Work Order ID 131353

Item ID: D205-541-043 Accept ***N900040100*** Setup Start ***NS1***
Revision ID: Stop ***NS2***
Item Name: Heli-Utility-Basket™ - LH
Start Date: 4/06/15 Start Qty: 1.00 ***1*** Cust Item ID:
Required Date: 4/16/15 Req'd Qty: 1.00 ***1*** Customer:
Reference:

DESIGN	DW	DART AEROSPACE LTD HAWKESBURY, ONTARIO, CANADA	
DRAWN	DW		
CHECKED	AP	DRAWING NO.	REV. A
MFG. APPR.	N/A	DSI 9667	SHEET 2 OF 2
APPROVED	<i>[Signature]</i>	TITLE	SCALE
DE APPR.		WASHER ADDITION	NTS
DATE	14.11.27	COPYRIGHT © 2014 BY DART AEROSPACE LTD THIS DOCUMENT IS PRIVATE AND CONFIDENTIAL AND IS SUPPLIED ON THE EXPRESS CONDITION THAT IT IS NOT TO BE USED FOR ANY PURPOSE OR COPIED OR COMMUNICATED TO ANY OTHER PERSON WITHOUT WRITTEN PERMISSION FROM DART AEROSPACE LTD.

FIGURE 1

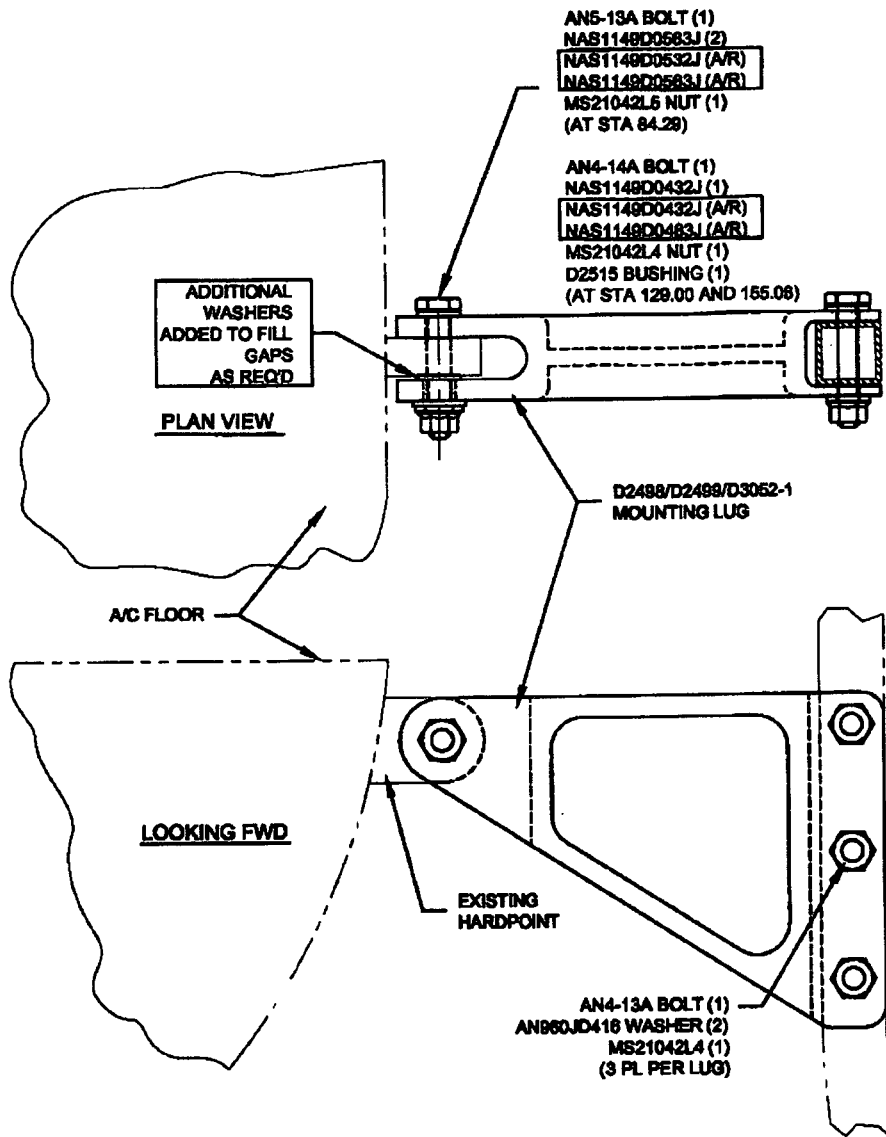
CHANGE:

INSTALL THE D205-541-043/-044/-045/-046 BASKET KITS PER INSTALLATION INSTRUCTIONS D205-541 WITH ADDITIONAL WASHERS AS SHOWN IN FIGURE 1 OF THIS SERVICE INSTRUCTION.
